RESOLUTION FLOOD PLAIN DEVELOPMENT
Nebraska Department of Roads, Highway 75 Platte River Bridge, Bellevue, NE
(AMENDED)

FLOOD PLAIN DEVELOPMENT PERMIT

Re: Updated Hydraulic Modeling Study at the US 75 -- Platte River Crossing

SUBJECT: Flood Risk and Floodplain Management Section Review of the Proposed U.S. Highway 75 Bridge and Roadway Approach Modifications in Relation to the Missouri River Federal Levee R613

1500'-0" 15-SPAN
STEEL WELDED PLATE GIRDER BRIDGE
WIDEN & REHAB
GENERAL PLAN & ELEVATION (2 OF 2)
DATE JULY, 2011
CHECKED BY DLS

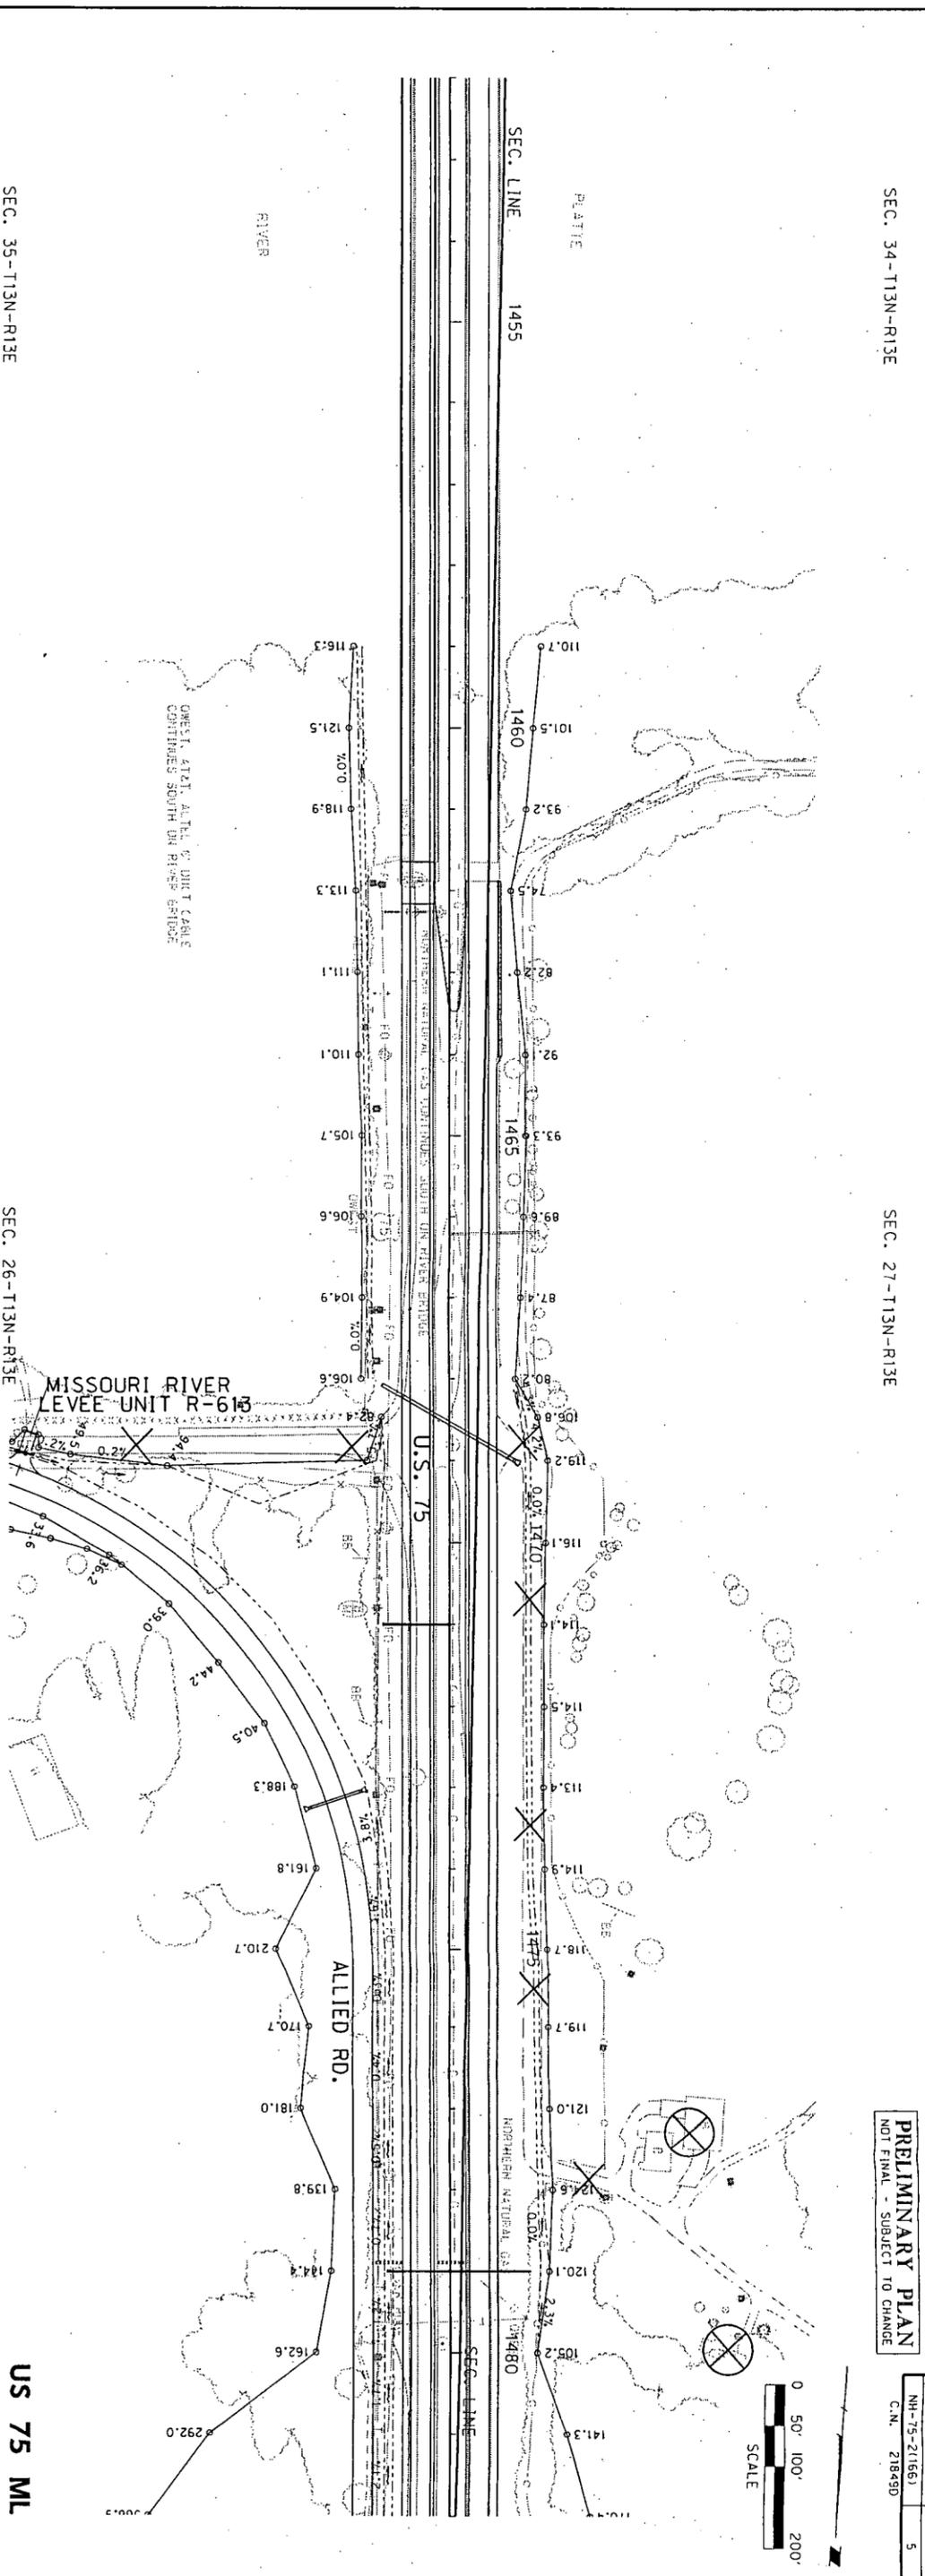
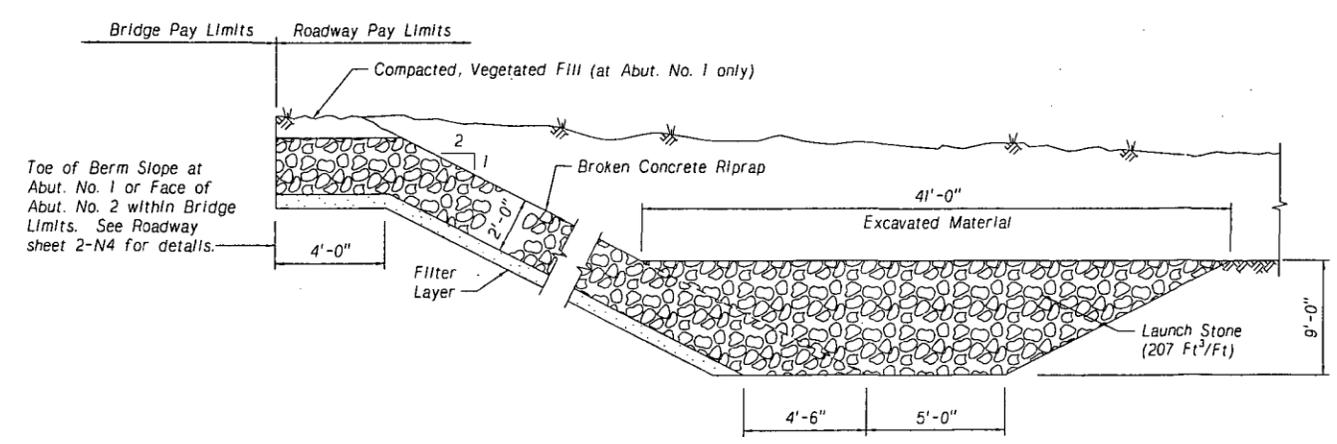
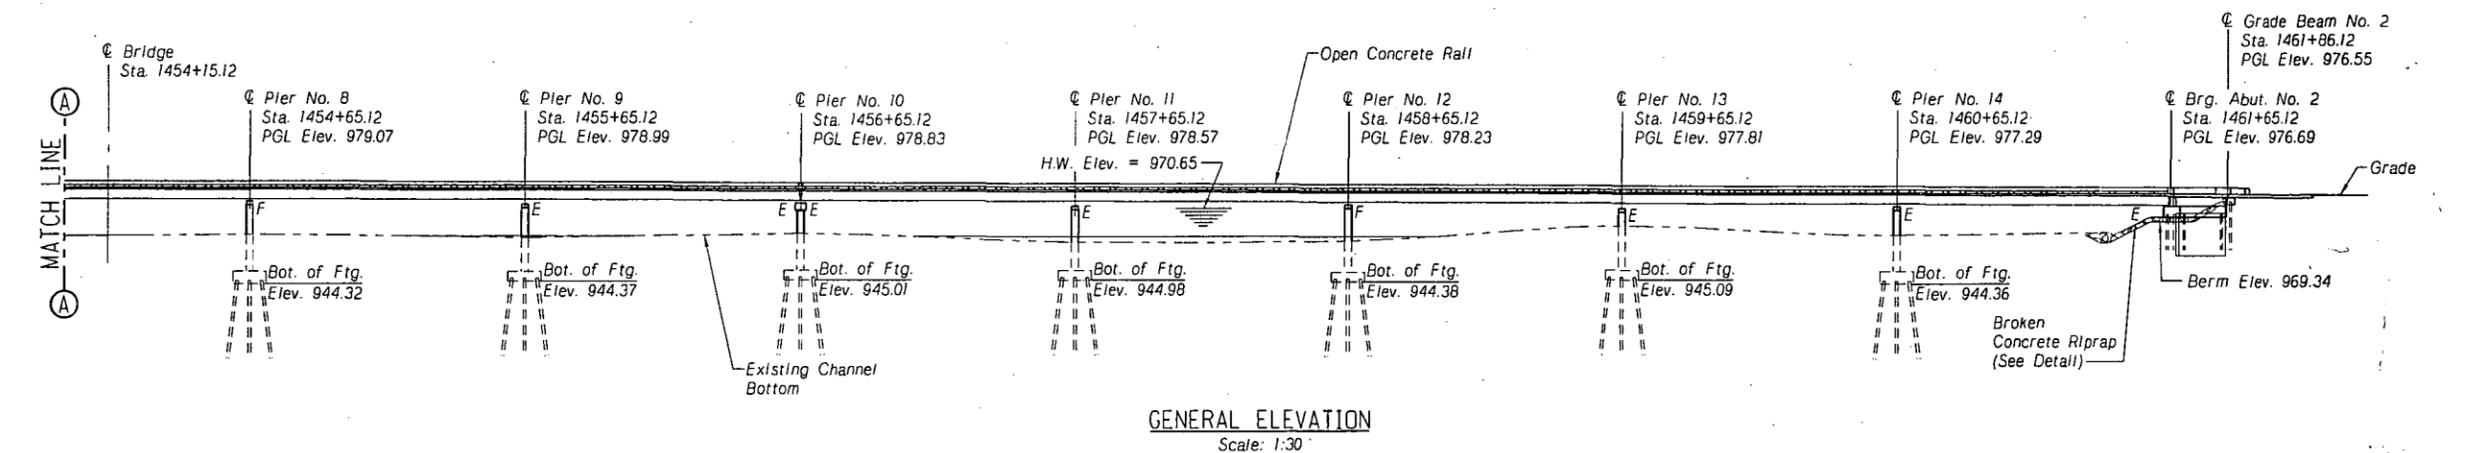
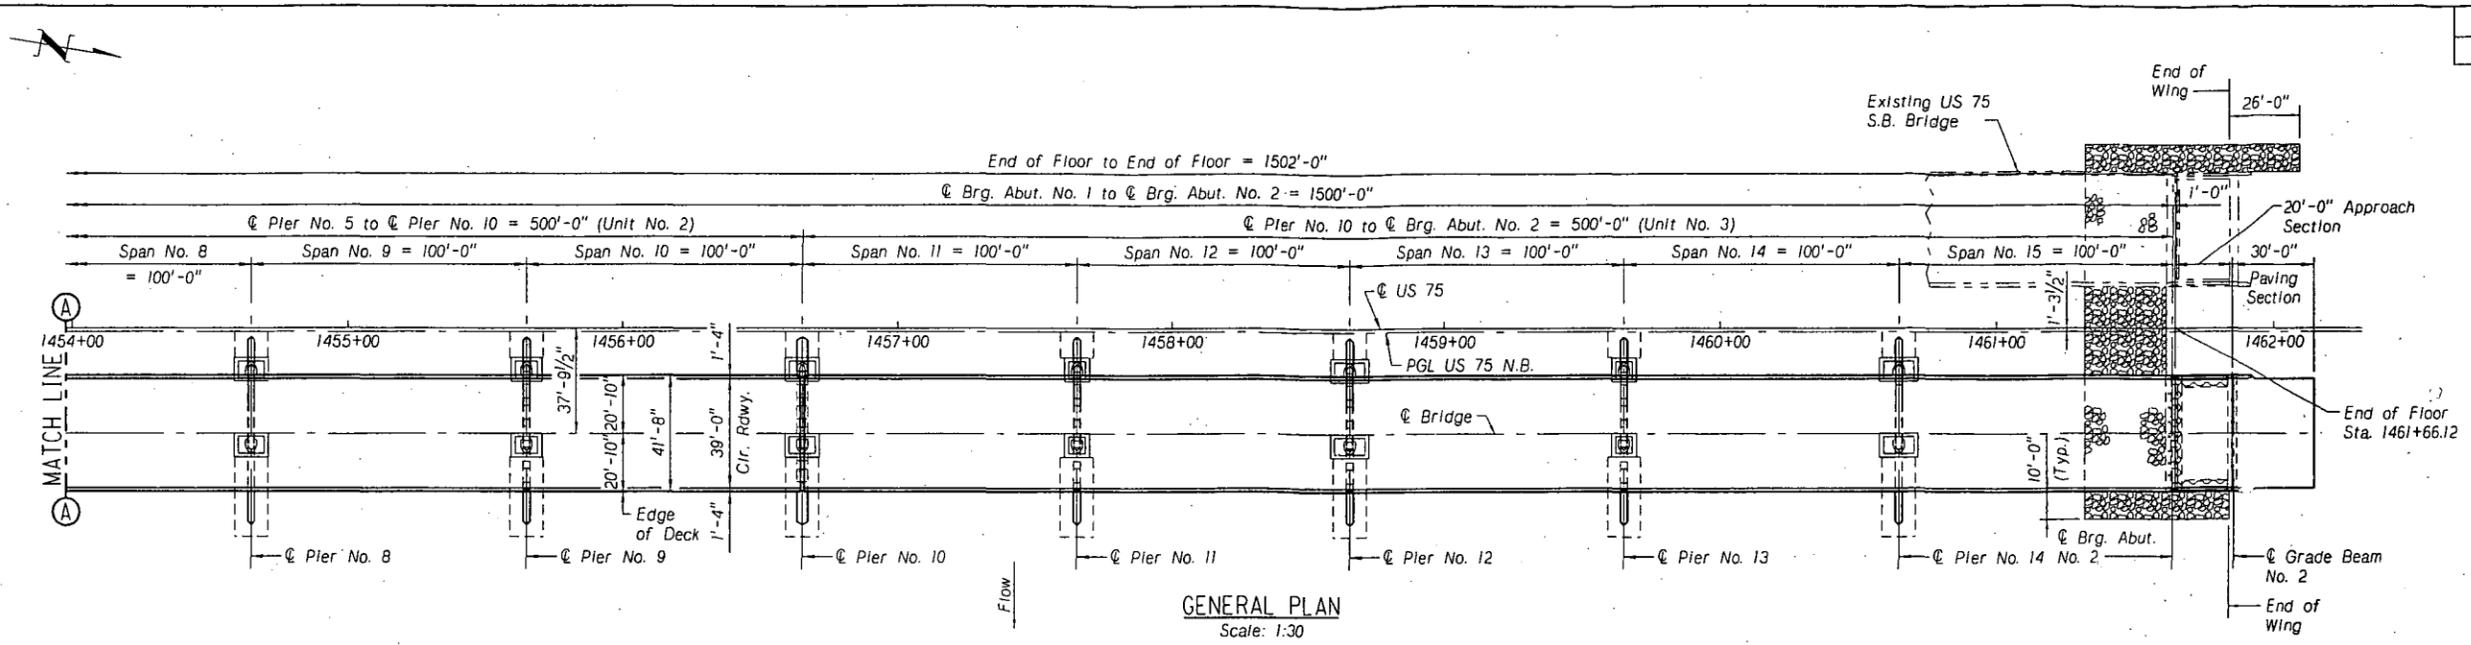
- In checking the proposed northbound bridge description (only bridge being modified by NDOR) I noticed that the plan set provided to me by NDOR shows an approximate 35' pier extension (26.75' downstream and 8.25' upstream) while the model describes a 24.6' extension. Matt stated that he understood the road deck was being widened 24.6'. He didn't realize that the plan set showed a 35' overall pier lengthening. He is going to look into that.

I will defer a formal report until the Corps has reviewed and commented on the HDR report and model. Also, HDR needs to provide justification on using a 24.6' pier extension instead of what appears to be a 35' pier extension. If I am right on the pier extension a new modeling effort and report would be required. Based on the modeling effort to date though, I do believe that improvements proposed by NDOR and described by HDR (contingent on pier length) will not substantially affect R-613 and may slightly improve it. It is noted that the floodplain below and above the US-75 corridor has changed due to sand pit lake developments and such. Since NDOR is not looking to or is responsible for providing new FEMA documentation and mapping but is only looking to improve a roadway under the constraints of not worsening the waterway - I do not believe they would necessarily need to provide the significant amount of funding required to obtain and incorporate new floodplain information. I believe they basically need to provide evidence of maintaining the equivalent or greater conveyance capacity at design flood stages within the left overbank, channel and right overbank areas. The modeling efforts provided appear to substantiate that NDOR is not increasing stage-frequencies by their proposed improvements.

The Papio-Missouri River Natural Resources Department reviewed and provided comments on the June 2011 version of this memorandum. The modeling performed for the June 2011 memorandum incorporated a deck width consistent with the proposed deck width and did not account for pier extensions beyond the proposed deck which would allow for future bridge expansion. The NRD requested that the modeled width of bridge be increased so that it is consistent with the proposed pier lengths. This change request resulted in increasing the modeled bridge width to 65.3 feet.

PROJECT NO. 75-2(167)
SHEET NO. 2-N4
C.N. 21849E

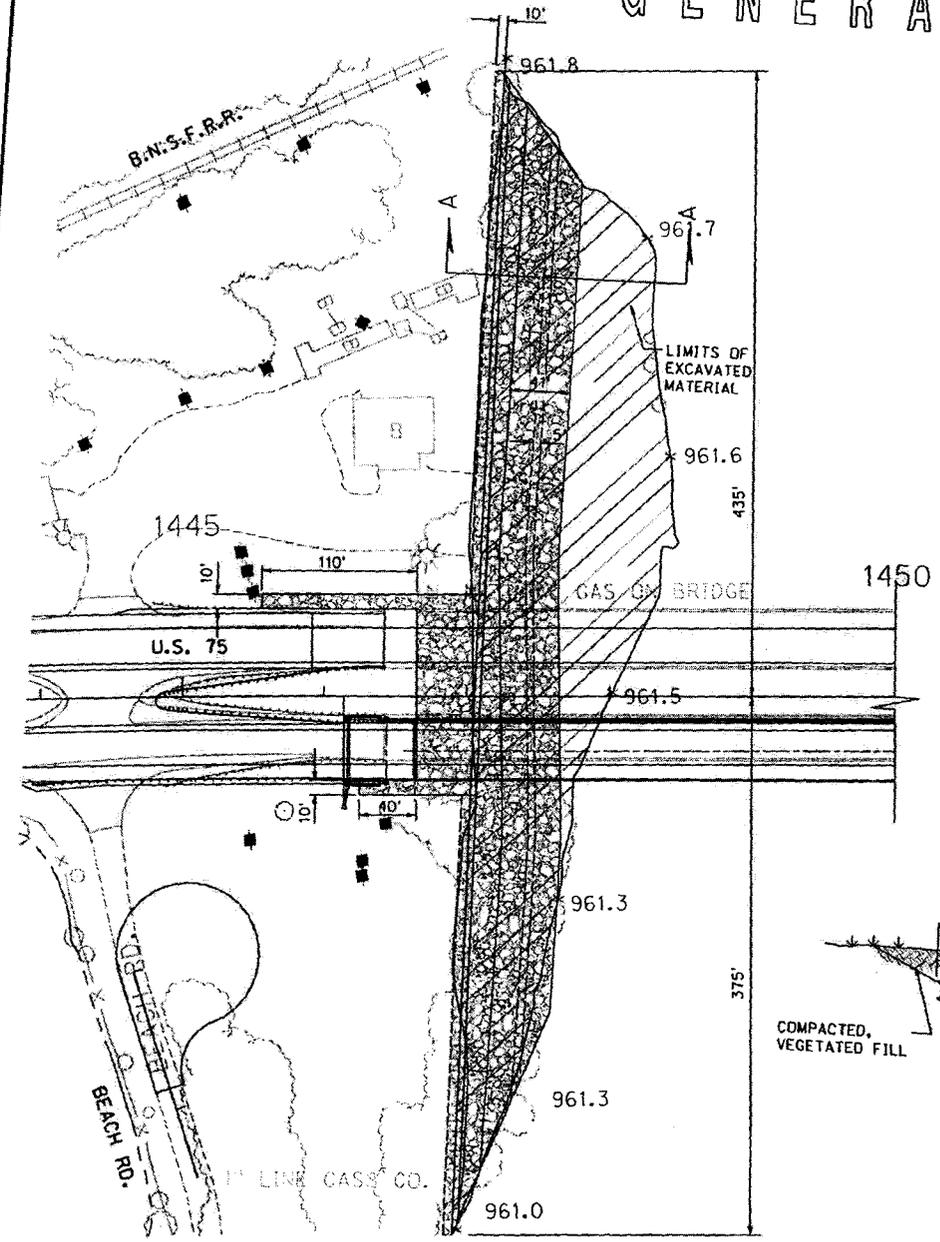
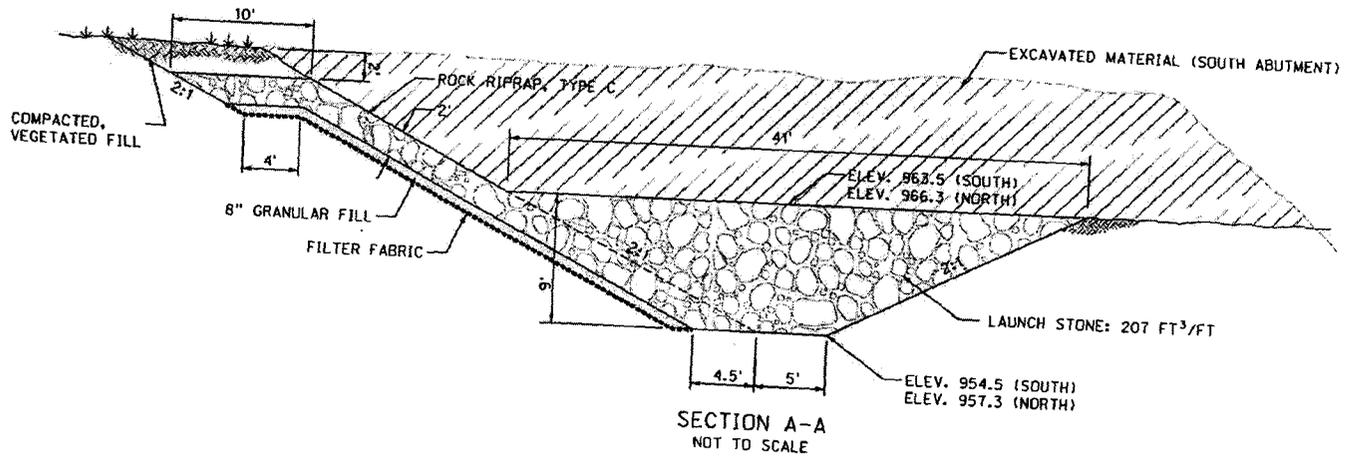
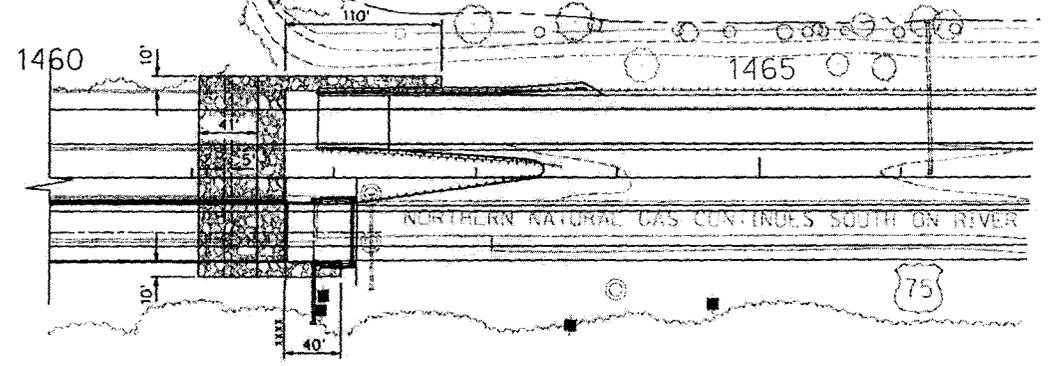
- It appears that the model and plans call for floodway mitigation by excavating an area for a distance of approximately 400 feet both upstream and downstream of the proposed bridge in order to meet no-rise condition for the 1% annual chance floodplain as required by FEMA. Draft language for a maintenance agreement was provided to the District by NDOR for review. The District has no further comments on the agreement.

The attached plan sheet will be included in the plans for the Plattsmouth to Bellevue project referenced above. The grading adjacent to the abutment is being completed to allow compliance with no-rise requirements. The graded area is coded in the hydraulic model to extend from the upstream face of the southbound Platte River Bridge to the downstream face of the northbound Platte River Bridge. This graded area will be protected from scour with Type C Riprap. This excavation area increases the conveyance area underneath the Platte River Bridge and is needed to prevent increases to water surface elevations in the post-construction condition. The graded area is partially on State right-of-way and partially on permanent easements.

Periodic removal of sediment may be required from the graded area in order to maintain the conveyance capacity of the Platte River Bridge crossing. The Nebraska Department of Roads agrees to inspect the excavation area at the south abutment of the Platte River Bridge on US-75 annually and after each high-water event on the Platte River. A high-water event shall mean flood stage at the United States Geological Survey (USGS) stream gage for the Platte River near Louisville or a stage of 9 feet or a river flow of 62,000 cfs. Any maintenance required to ensure the area remains open as shown on the plan sheet will be performed as soon as possible.
